Board of Architectural Review

DATE: January 15, 2020
TO: Board of Architectural Review Chair and Members
THROUGH: Jason Sutphin, Community Development Division Chief (JDS)
FROM: Tommy Scibilia, BAR Liaison (TS)
SUBJECT: Wawa

1. Case Number:	BAR-19-00913
2. Addresses:	10521 Fairfax Boulevard
3. Request:	Exterior building modifications
4. Applicant:	Wawa, Inc.
5. Applicant's Representative:	Chris Howell
6. Status of Representative:	Agent
7. Zoning:	CR Commercial Retail, Architectural Control Overlay District

Detail of damaged cornice on south elevation

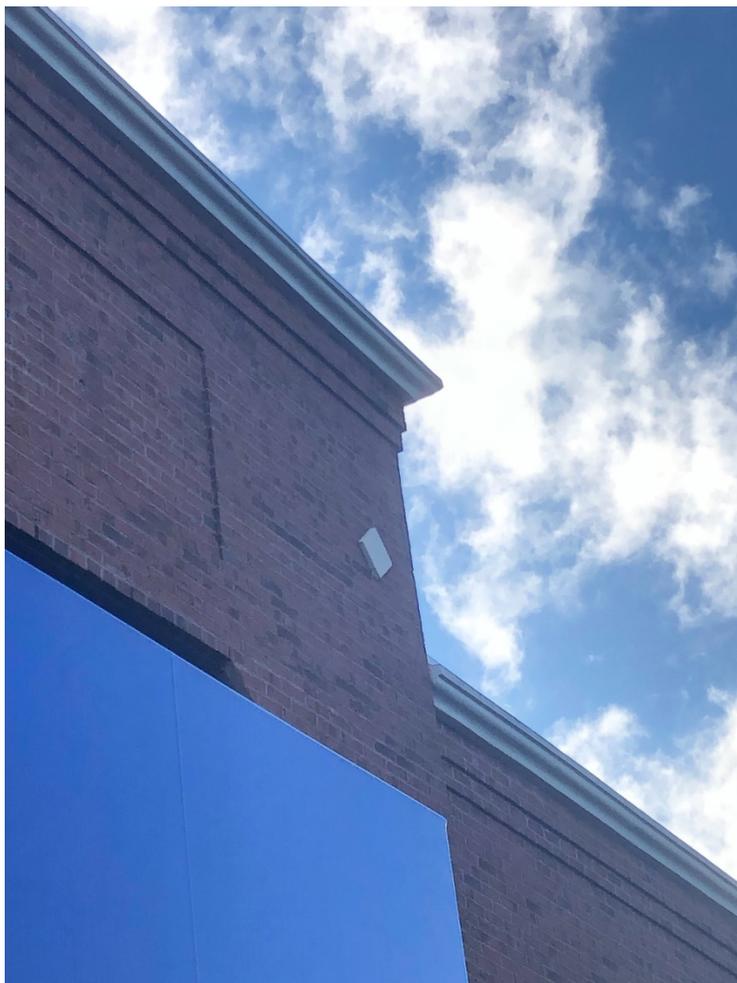
Staff finds the retention of the cornice, diamond-shaped recesses, and brick recesses, as well as the proposed addition of accent materials, suspended awnings, and decorative wall sconces to be in conformance with the above guideline. Staff believes that the cornice needs to be repaired and repainted in certain areas.

3. The railing at the top of the retaining wall shall be repainted black.
4. The EIFS cornice shall be repaired as needed and repainted the existing color.

Front Elevation (Fairfax Blvd)

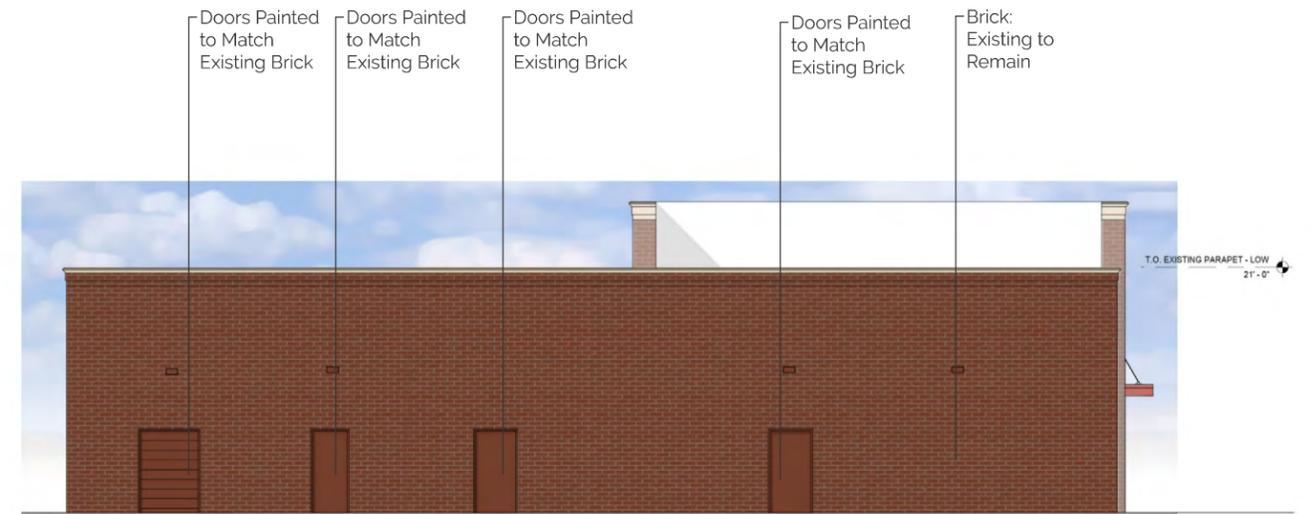
Staff finds the introduction of the faux wood panel, flat metal awnings, and decorative wall sconces to be appropriate interventions for breaking up the scale of the building and creating a human scale. The retention of certain existing architectural features, such as the diamond-shaped recess surrounds, recessed brick banding, cornice, and rectangular parapet recesses is an effective no-cost method of maintaining existing scale-reducing features of the building design.

Staff finds the modified design of the main entrance at the northeast corner of the building to effectively maintain transparency, and the introduction of dark bronze to the storefront area to be appropriately echoed in other metal design elements of the proposal, such as the lighting fixtures, and bollards. Staff does not object to the infill of the diamond-shaped window recesses with the faux wood panel that echoes the accent material of the main entrance.

Staff finds the proposed suspended awnings to be consistent with the guidelines above. The use of red is an appropriate accent to the overall color scheme.

Trash - Left Elevation (Chain Bridge Blvd)

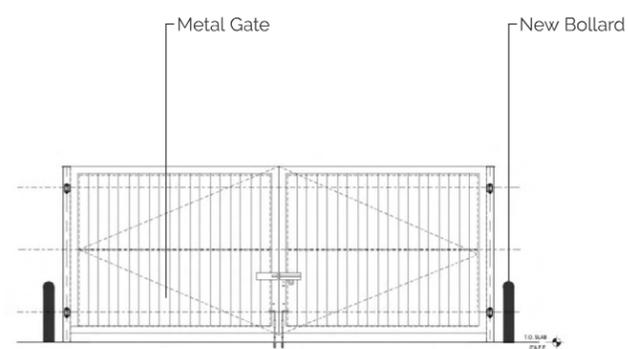
Staff finds the design of the dumpster enclosure to be consistent with these guidelines. As stated above, staff believes that the retaining wall should be washed to return it to its original appearance. This should be done before any field matching is done for the new dumpster enclosure wall material.

1. The brick of the building and split-face CMU of the retaining wall and dumpster enclosure shall be cleaned to remove staining and buildup.
2. The applicant shall field match the material of the proposed dumpster enclosure wall with the existing retaining wall after it has been cleaned, and provide photo documentation of the field match to planning staff.
